**TOPOGRAPHIC SURVEY  
SEASPECT SHORT PLAT  
JOHN KAHAN**

PERMIT DRAWINGS  
 DATE: 06.10.22  
 SHEET SIZE: D (24X36)  
 REVISIONS

PROJECT TITLE:  
**Clarkson Residence**  
8163 West Mercer Way  
Mercer Island, WA 98040

1 PROPOSED SITE PLAN  
1" = 10'-0"

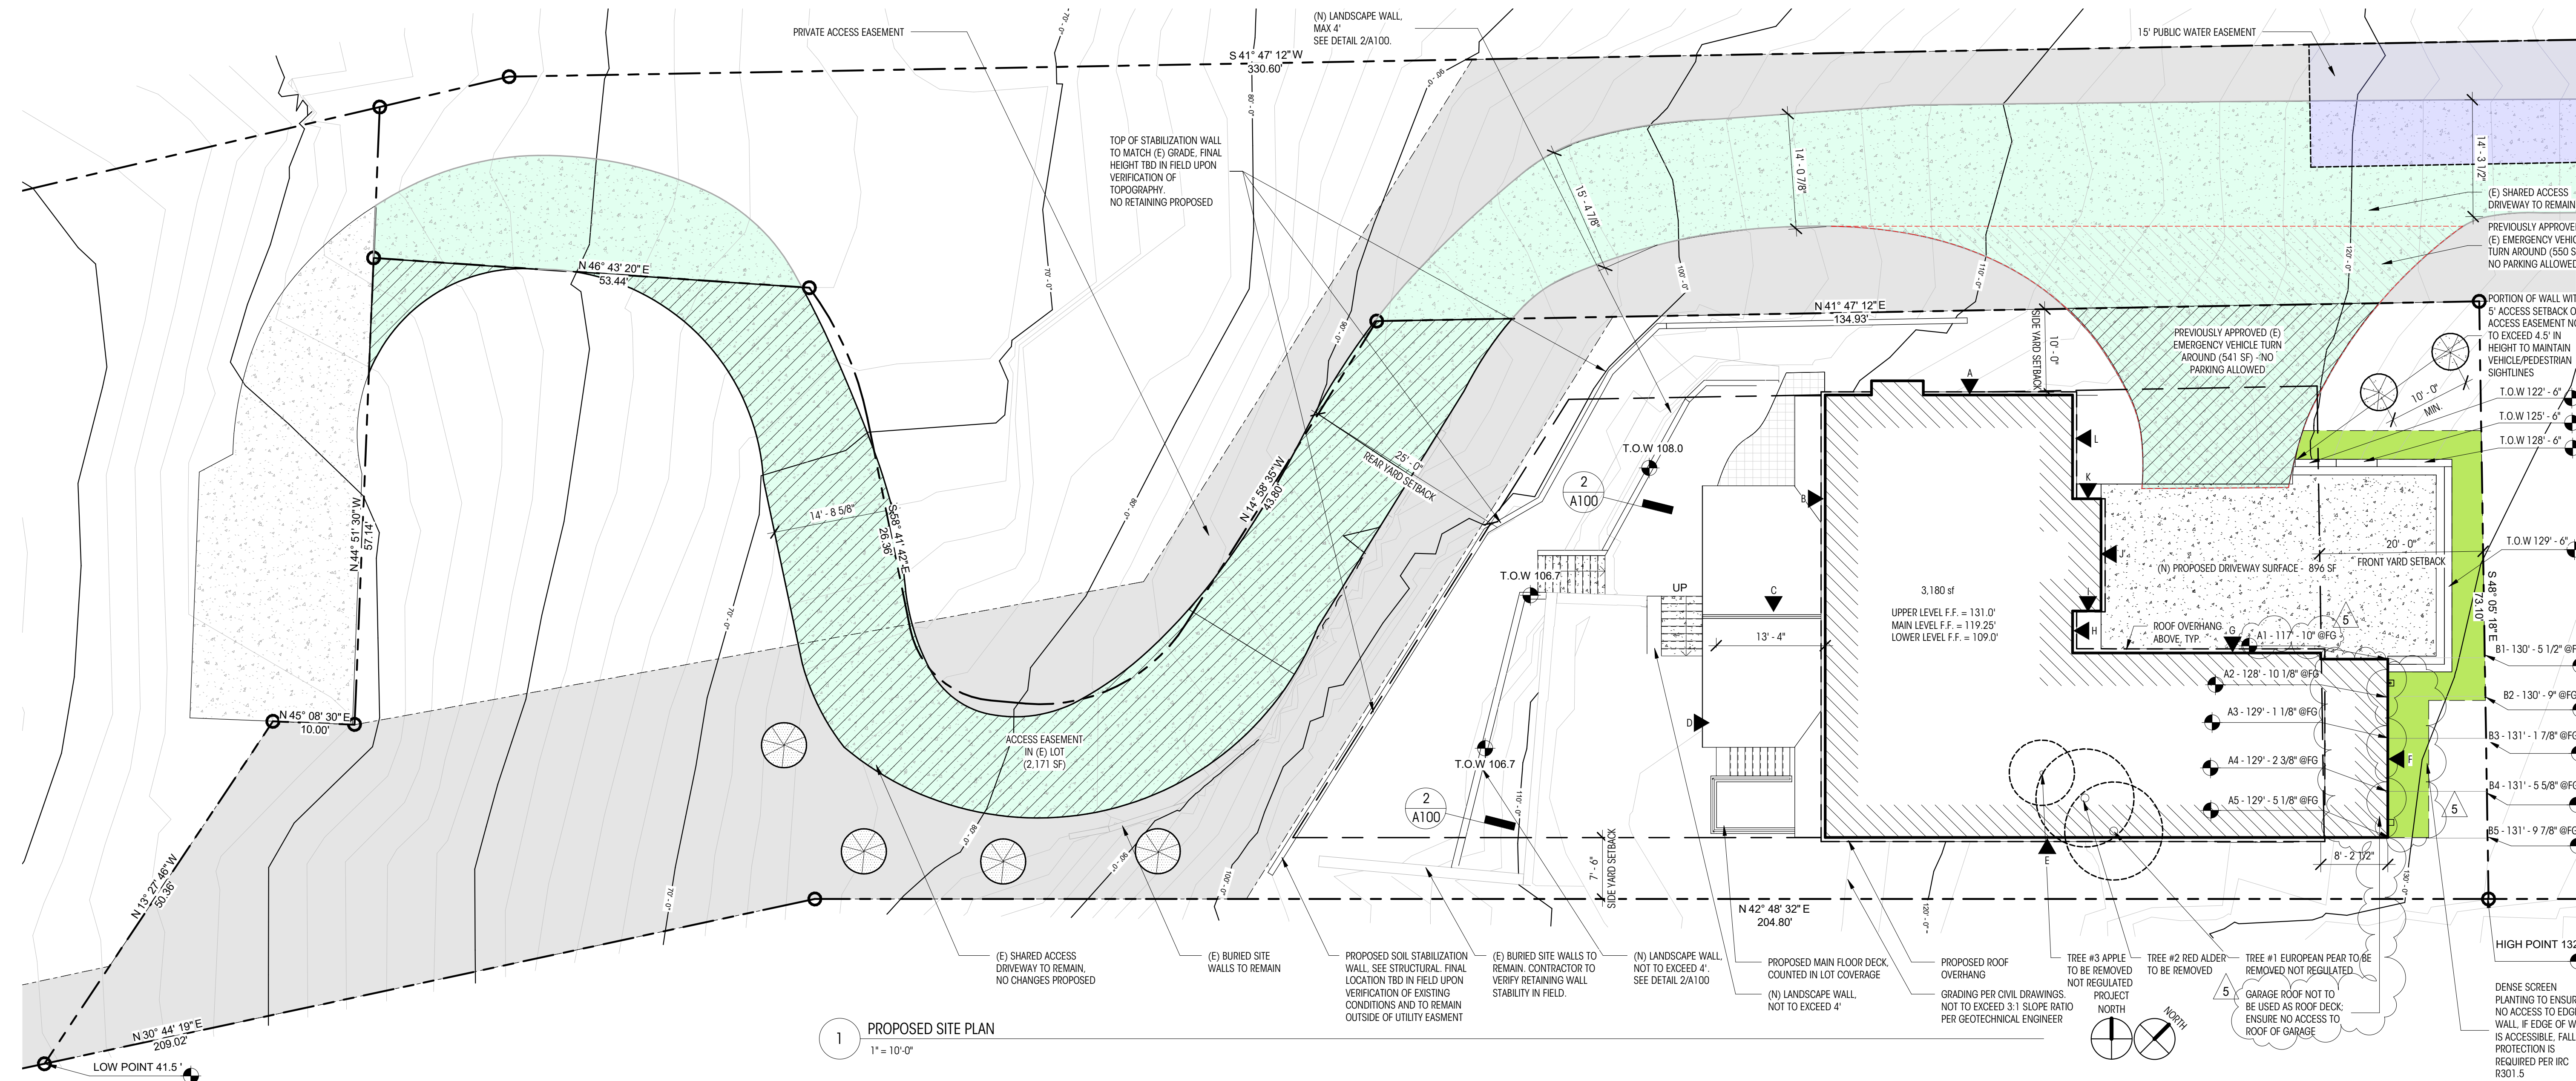
- NO CHANGE TO ROOF OVERHANGS AT SETBACKS
- NO CHANGE TO VARIABLE SIDE YARD SETBACKS
- NO CHANGE DOWNHILL SLOPE GRADE OR RIDGE HEIGHT
- EXTEND GARAGE EAST INTO FRONT YARD SETBACK AS ALLOWED BY CODE 19.02.040.D

- FRONT YARD ENCROACHMENT CALCULATIONS ADDED
- SHIFT OF PARKING RETAINING WALLS TO NORTH AND SOUTH
- CHANGE ROOF OF AND EXTEND WESTERN PATIO TO THE WEST AND SOUTH

- CHANGE IN SOIL RETENTION WALL, PREVIOUSLY AS PART OF FOUNDATION SYSTEM, NOW MOVED TO WESTERN YARD ADJACENT TO ROAD IN ORDER TO ALLOW FOR LANDSCAPE WORK

- REVISED LEGAL DESCRIPTION AS A RESULT OF PROPERTY SALE
- CHANGE TO LOT COVERAGE AS A RESULT OF SHIFTED PARKING RETAINING & EXTENDED COVERED DECK
- CHANGES TO HARDSCAPE CALCULATIONS AS A RESULT OF SOIL STABILIZATION WALL, PATIO EXTENSION AND SITE STAIRS

- CHANGES TO GFA AS A RESULT OF EXTENDED GARAGE AND EXTENDED COVERED DECK
- REVISED LOCATION TO REPLACEMENT TREES
- CHANGE TO ABE AS A RESULT OF EXTENDED GARAGE AND EXTENDED COVERED DECK

- GRAPHICS/PATTERNS/HATCHES HAVE BEEN COORDINATED FOR CONSISTENCY
- MEETS AND BOUNDS ADDED TO ALL PROPERTY LINES

1 PROPOSED SITE SETBACK & BUILDING PAD PLAN  
1" = 10'-0"

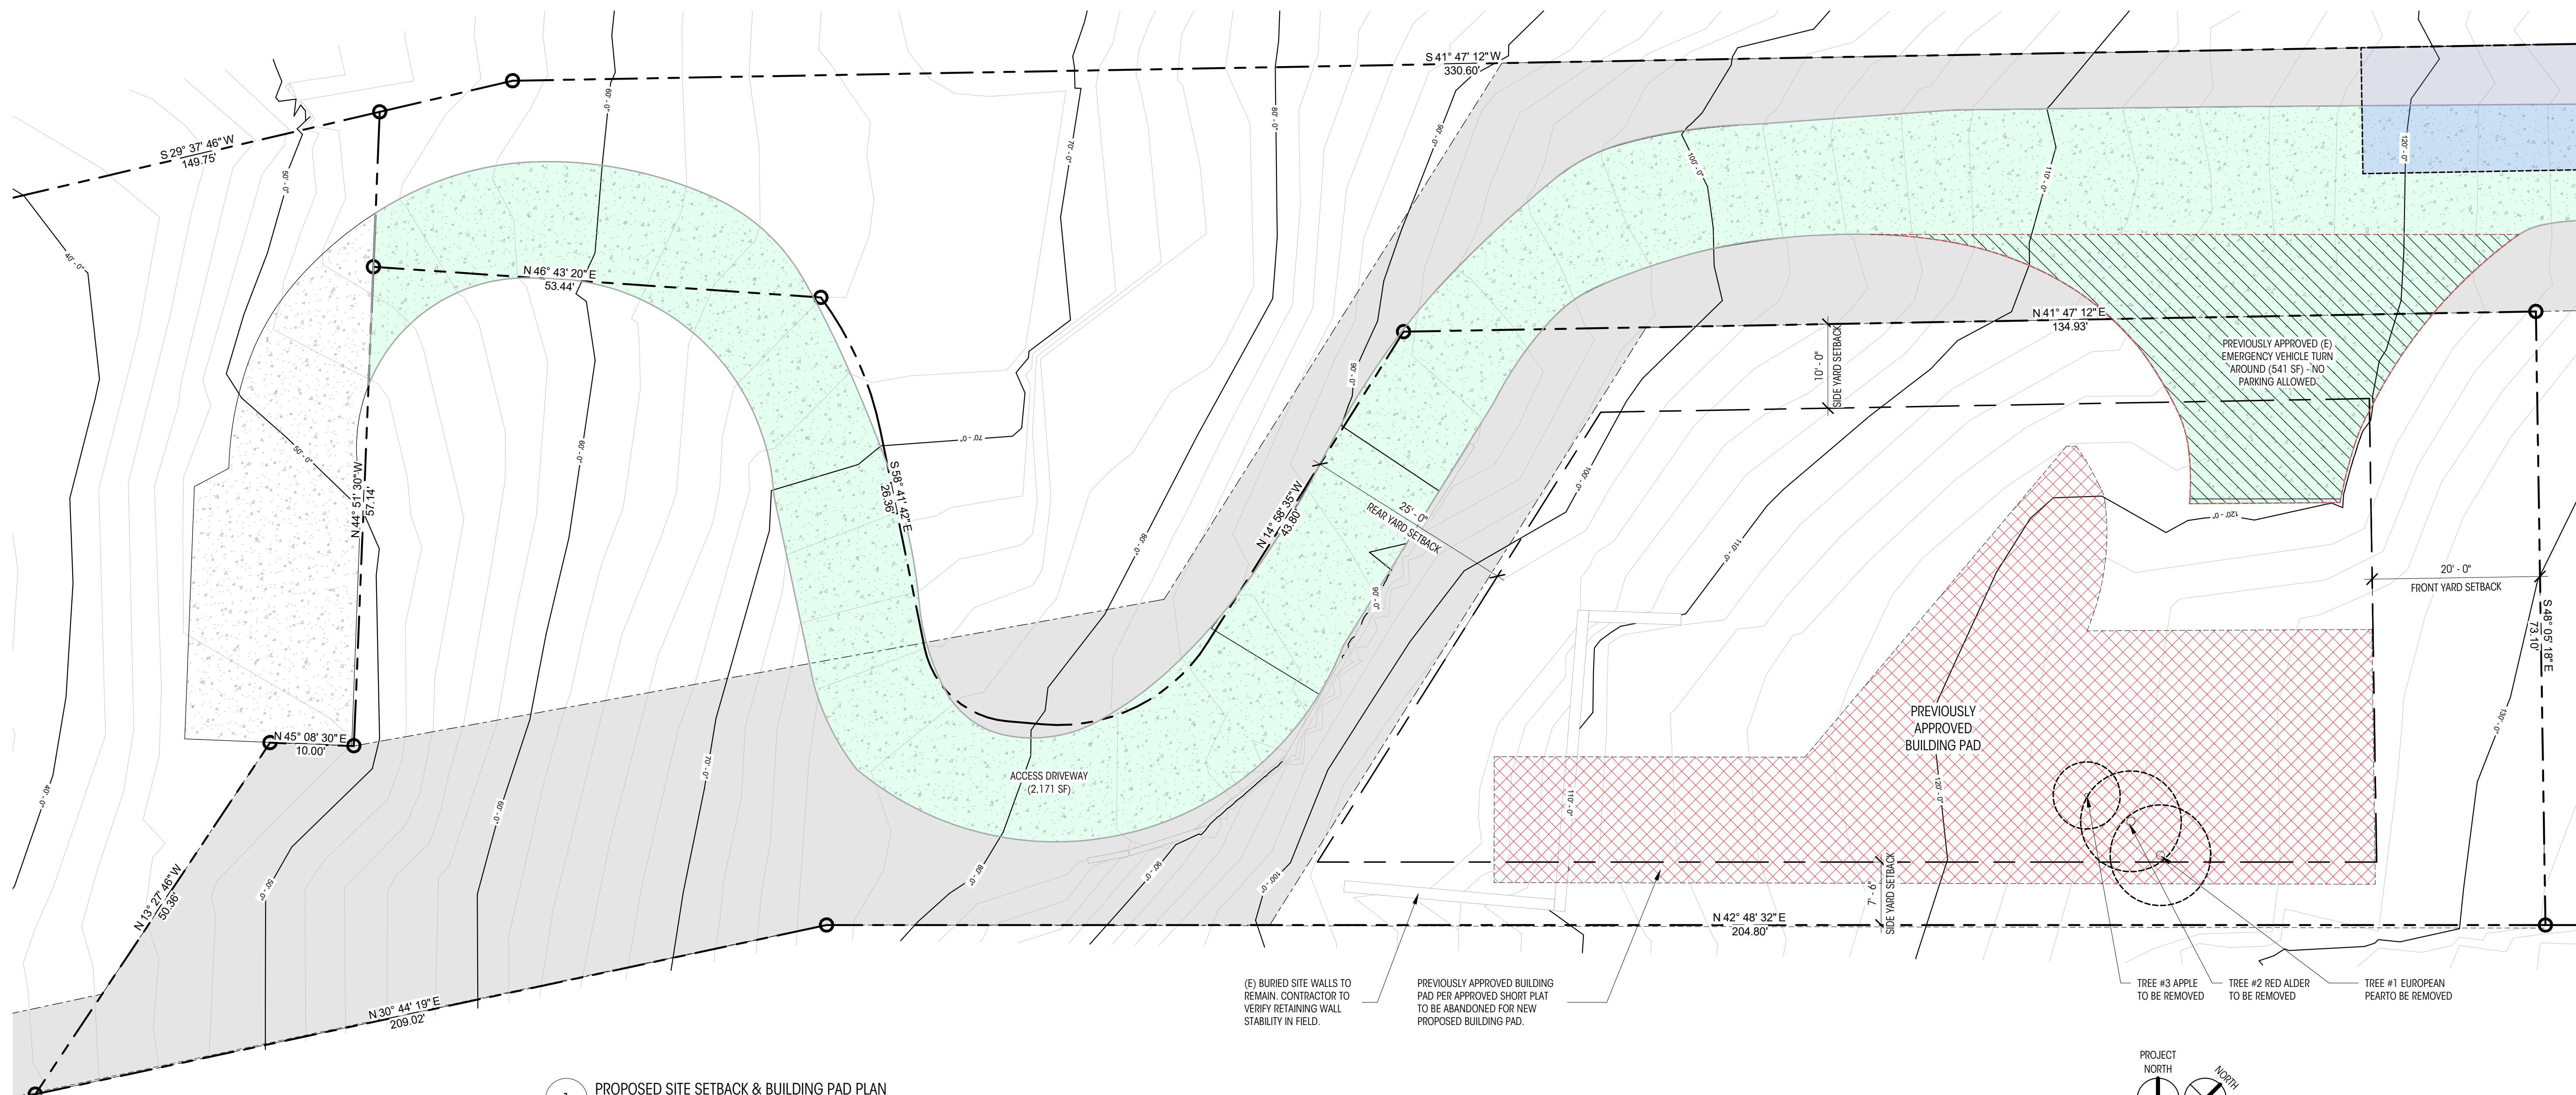
- CHANGE IN SOIL RETENTION WALL: PREVIOUSLY AS PART OF THE FOUNDATION SYSTEM, NOW MOVED TO WESTERN YARD ADJACENT TO ROAD IN ORDER TO ALLOW FOR LANDSCAPE WORK
- REVISED FOUNDATION AS A RESULT OF SOIL STABILIZATION WALL LOCATION MOVE.
- LEVEL CHANGES: DRIVEWAY & GARAGE LEVEL DROP BY 15"; BASEMENT LEVEL DROP BY 12".
- GRAPHICS/PATTERNS/HATCHES HAVE BEEN COORDINATED FOR CONSISTENCY
- ADDITIONAL GRADING PROPOSED AS A RESULT OF THE ADDED LANDSCAPE WALLS.

1 NORTH - SOUTH SECTION  
3/16" = 1'-0"

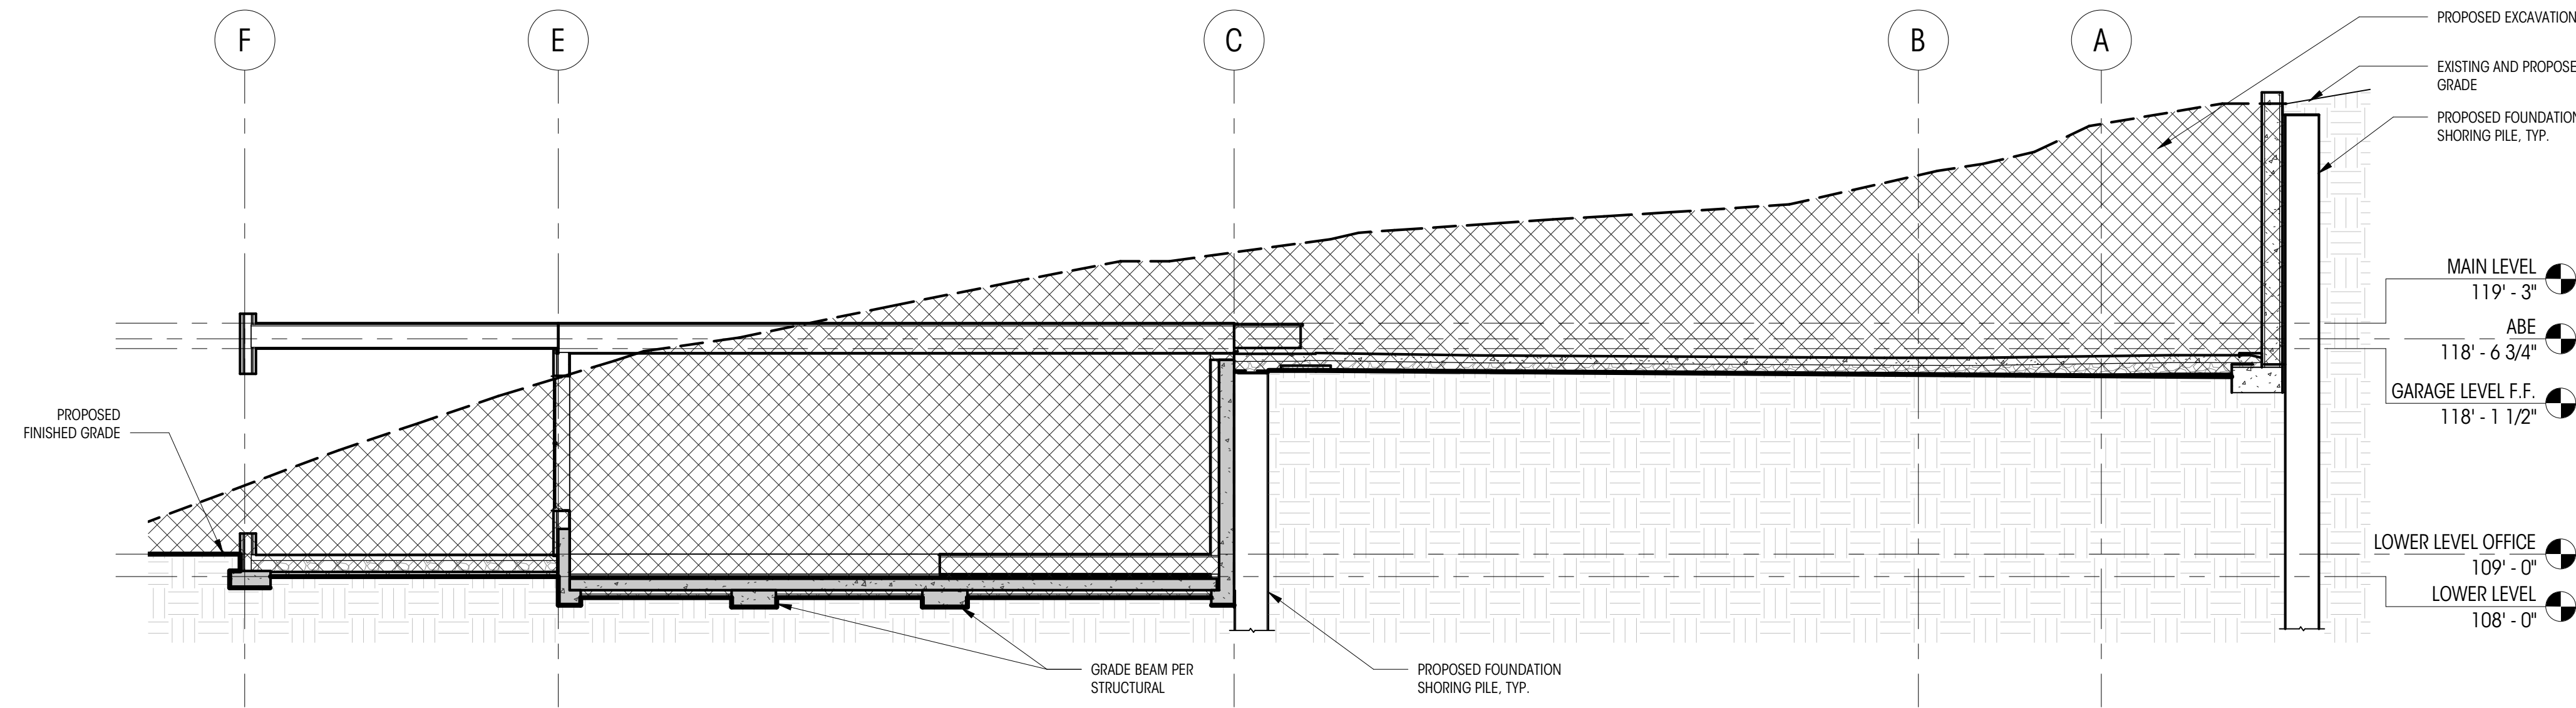
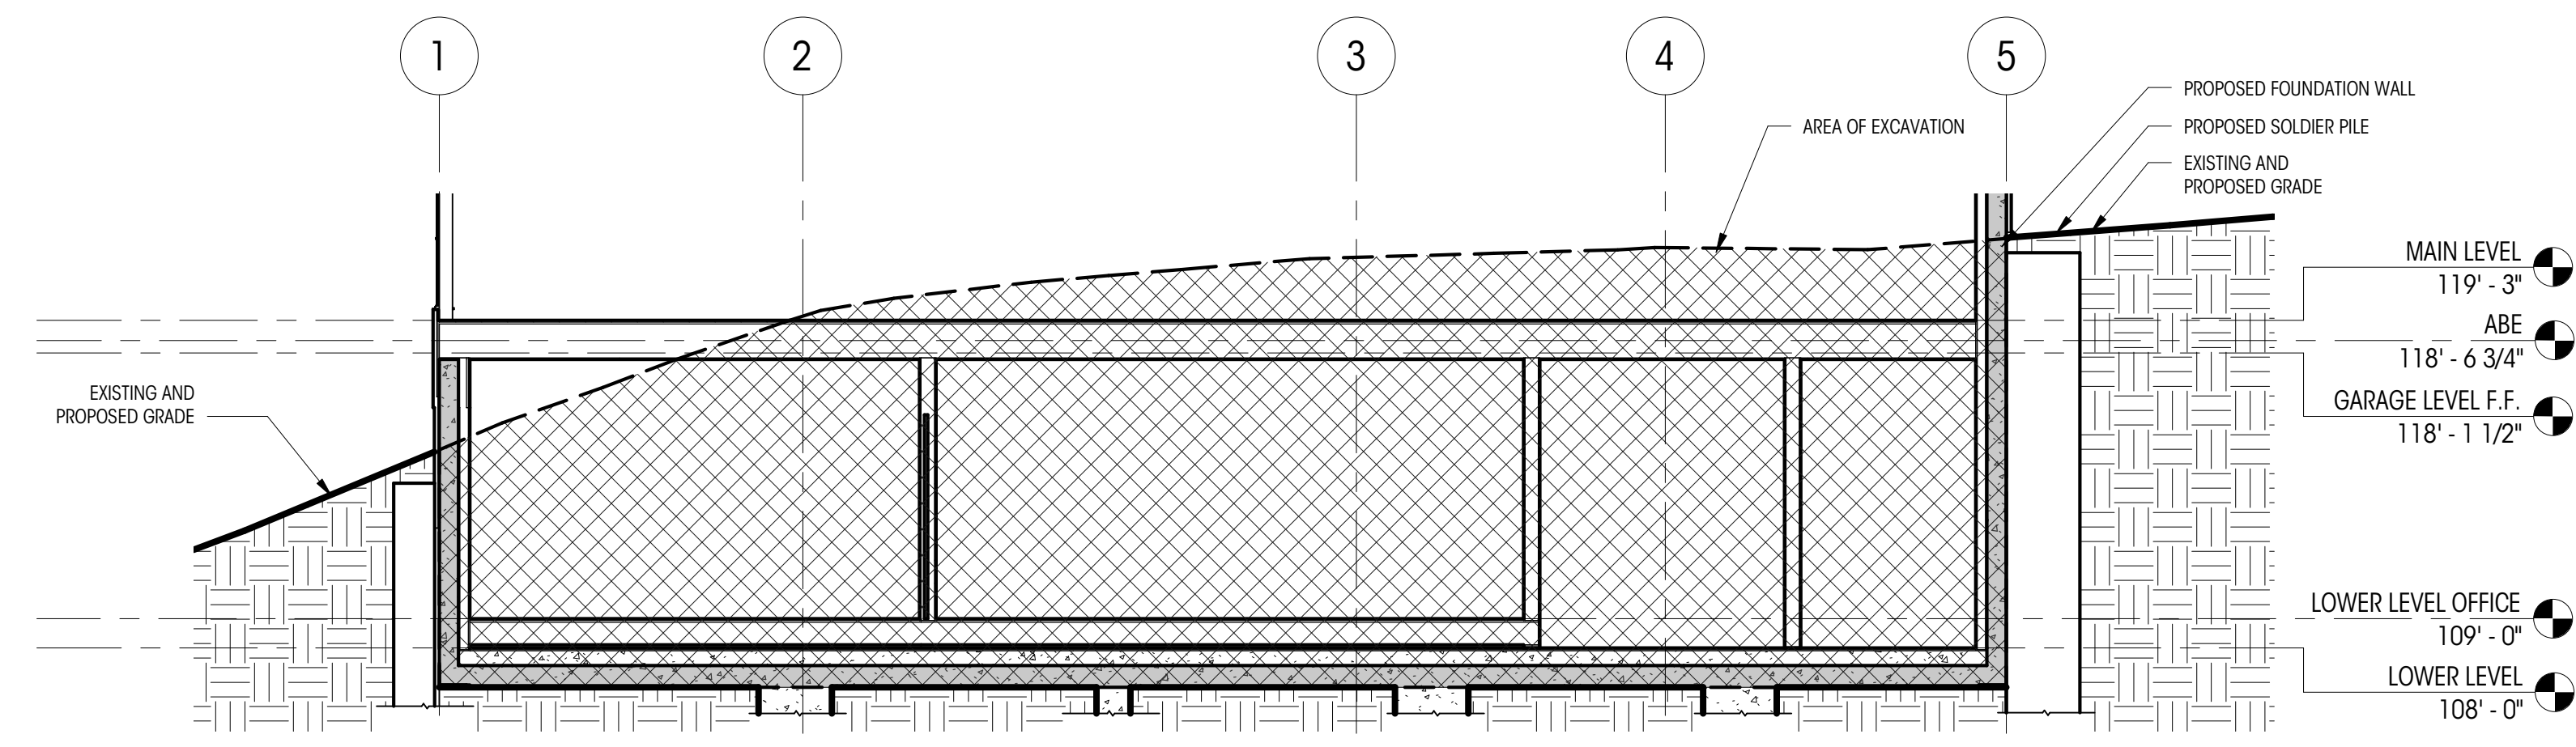
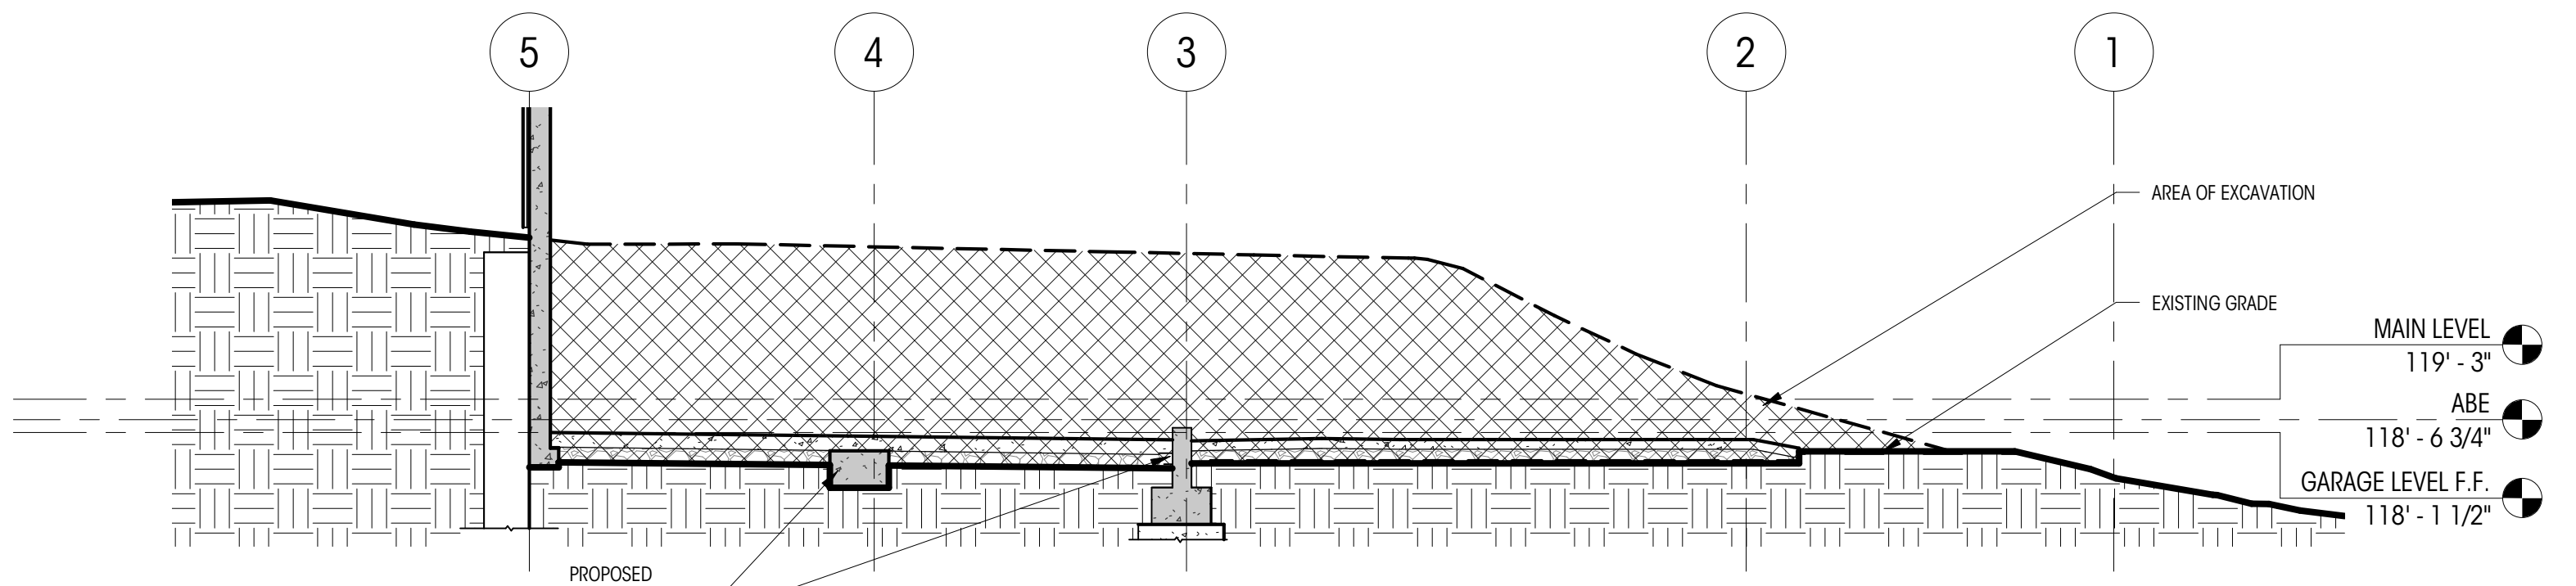
- LEVEL CHANGES: DRIVEWAY & GARAGE LEVEL DROP BY 15"; BASEMENT LEVEL DROP BY 12"
- CHANGE TO ABE AS A RESULT OF EXTENDED GARAGE AND EXTENDED COVERED DECK
- VIEW NUMBERING HAS BEEN UPDATED FOR CONSISTENCY
